2401 WASHINGTON AVE.

harmandeutsch
ARCHITECTURE

COMPLETE STREETS HANDBOOK CHECKLIST

Philadelphia City Planning Commission

ZONING PLAN
SCALE: 1" = 40'-0"

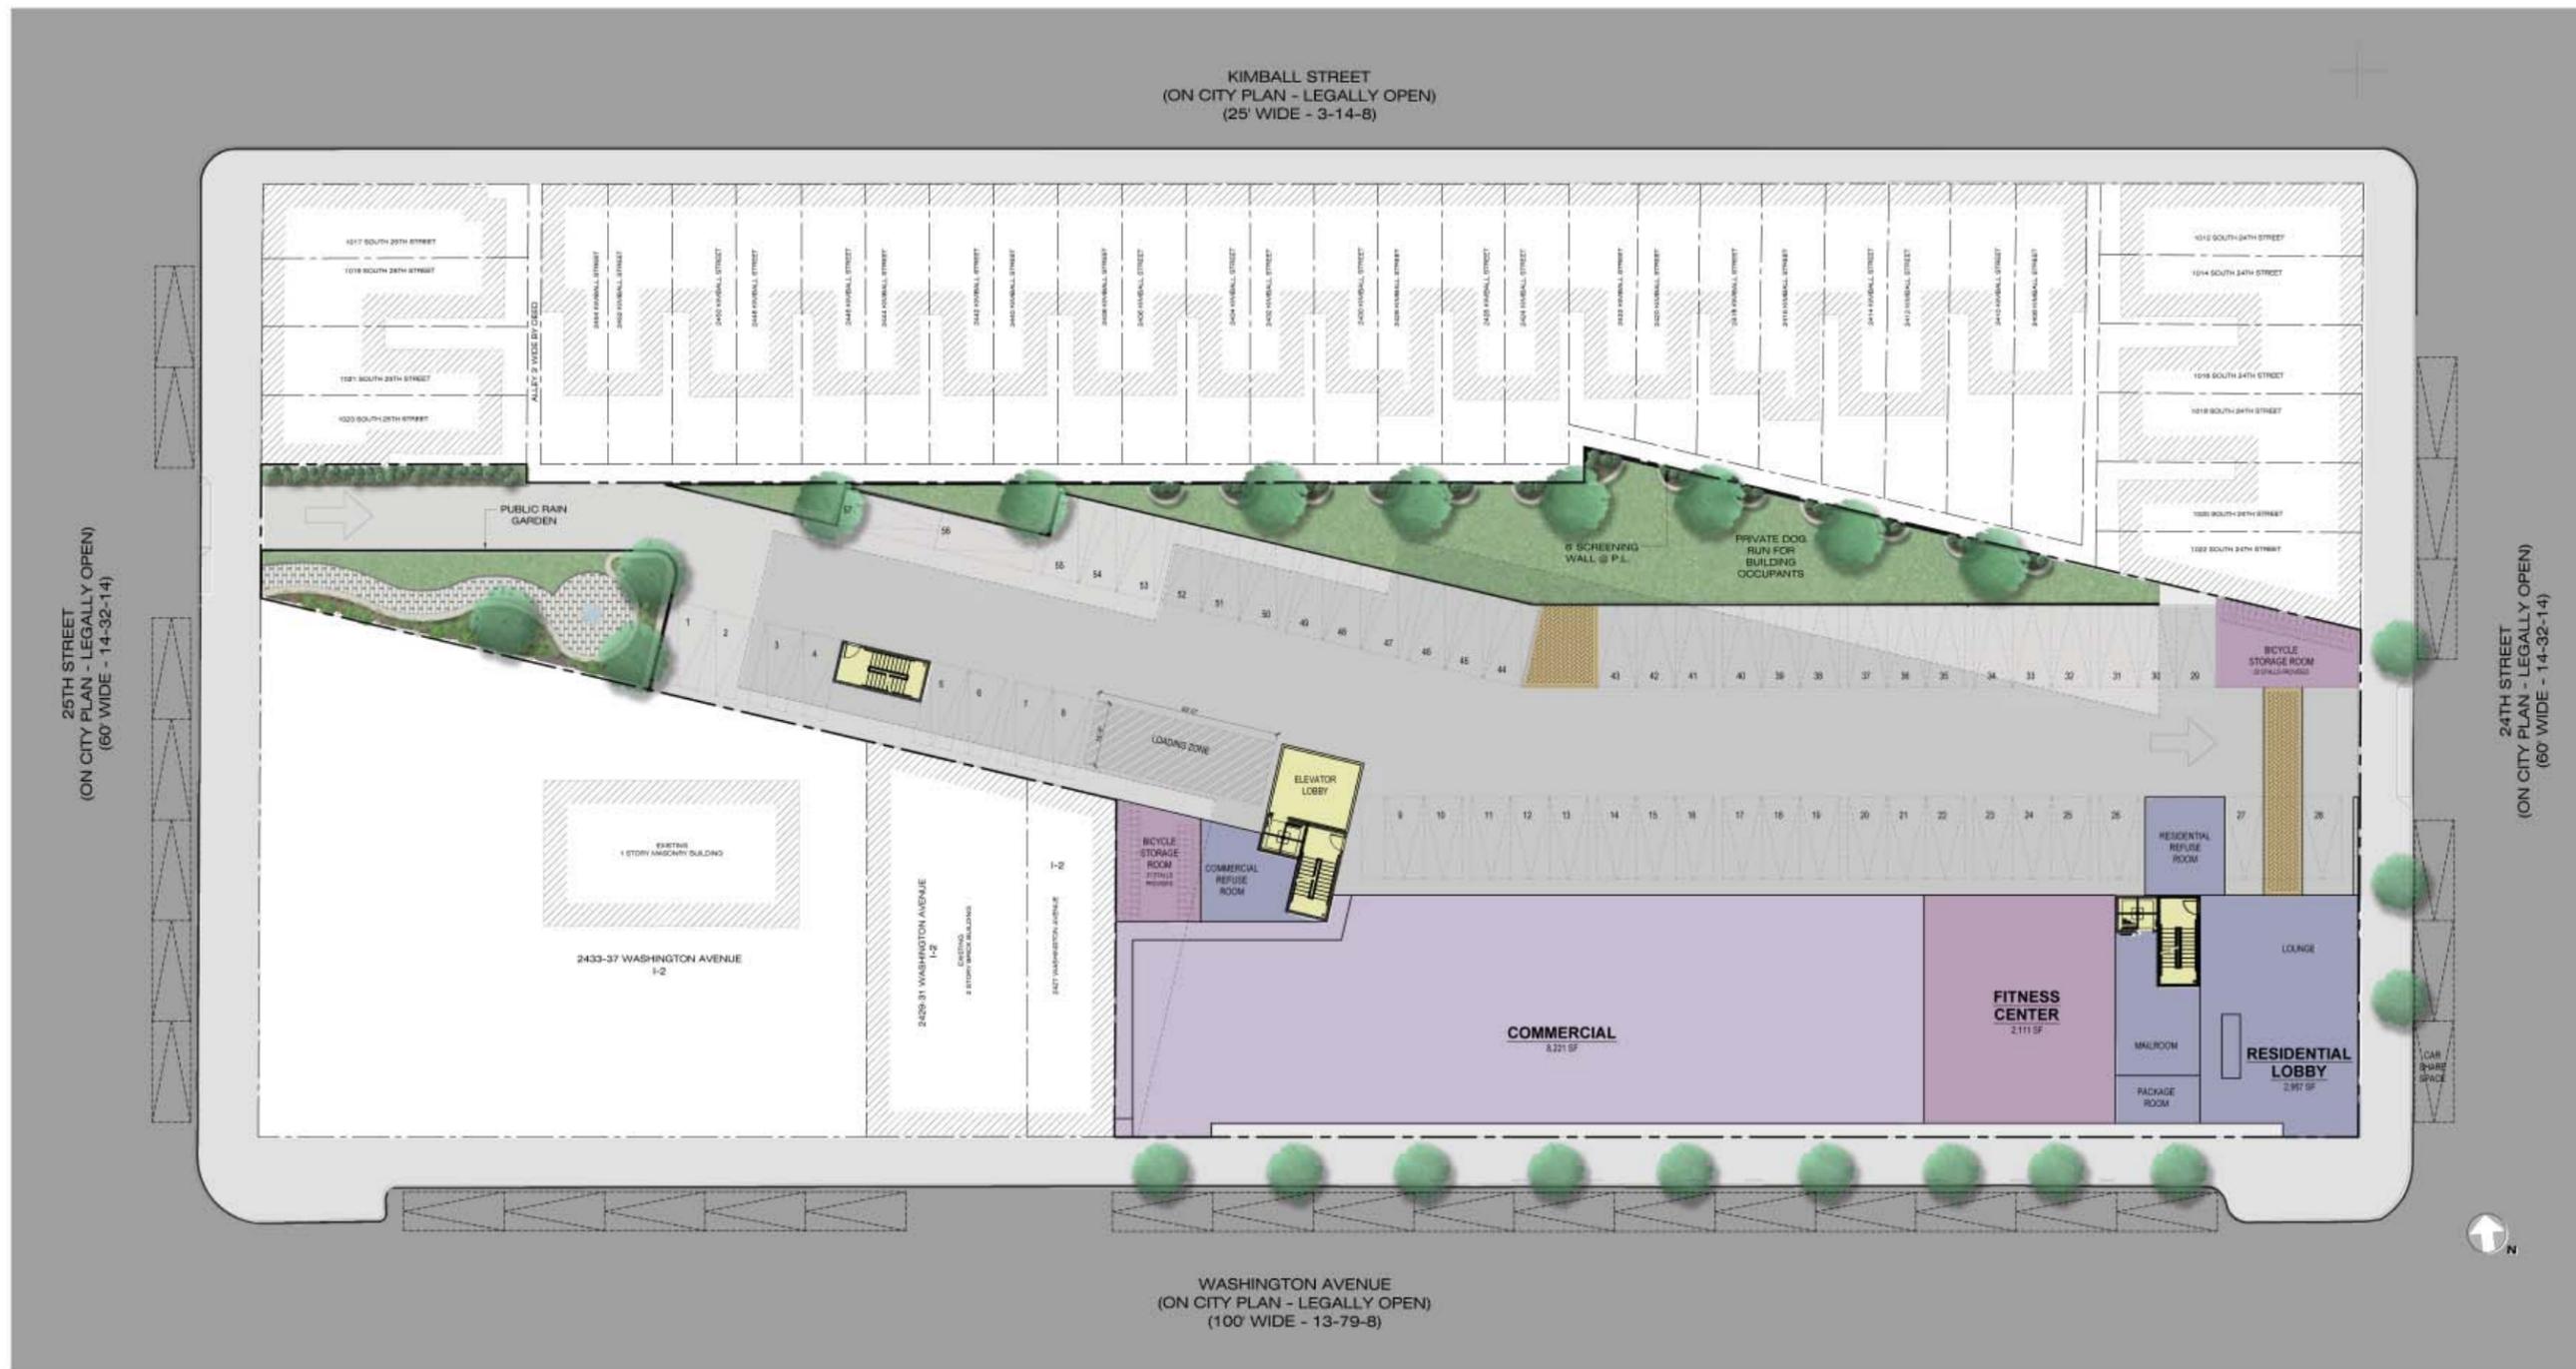
Question 12: Is the applicant dedicating a portion of the parcel to the City to serve as sidewalk? If not, the sidewalk width, though proposed as part of the building zone to 14', does not count as part of the City Plan sidewalk width.

Question 13: If the sidewalk IS dedicated to the City, then the walking zone requirement is 7', which is half of the 14' sidewalk. Streets will require an increase in the walking zone from 6' to 7' and this should be amended on the plans.

Question 14: The driveway curb cut on 25th Street frontage is incorrectly listed. On the plans it is 24'.

Question 15: Streets Department will require the two ADA ramps at 24th and Washington to be reconstructed to current standards. Include this on the plans.

Question 16. The proposed building zone width on Washington is duplicative to the measurements in question 12. Either the sidewalk width is building zone or dedicated sidewalk, not both.

Question 21. Street trees do not comply with installation requirements. Trees cannot be within 20' of an intersection or light. There are several trees that may be rejected by the Streets Department. Consider relocating to meet location requirements.

Question 24. The plan lists the bicycle parking as 57 spaces, not 53. Which is correct? Where are the on-street bicycle parking spaces? They do not appear on the plan. Why is there an in-street bicycle parking corral here? That feature is typically included only in a location with demonstrated high bicycle demand and a lack of on-street or in-building parking. The Streets Department will request removal of that item. Instead, consider placing U racks on-street on Washington Avenue, parallel to the curb.

Please consider a sign internal to the site to warn motorists of bicycle traffic against traffic, as cyclists coming from Center City will likely use 24th Street to access the internal bicycle parking.

Question 35. There is a proposed loading zone on the plan on Washington Avenue, contrary to the answer of No here. Instead, consider rearranging internal parking to accommodate residential and commercial loading in the parking lot.
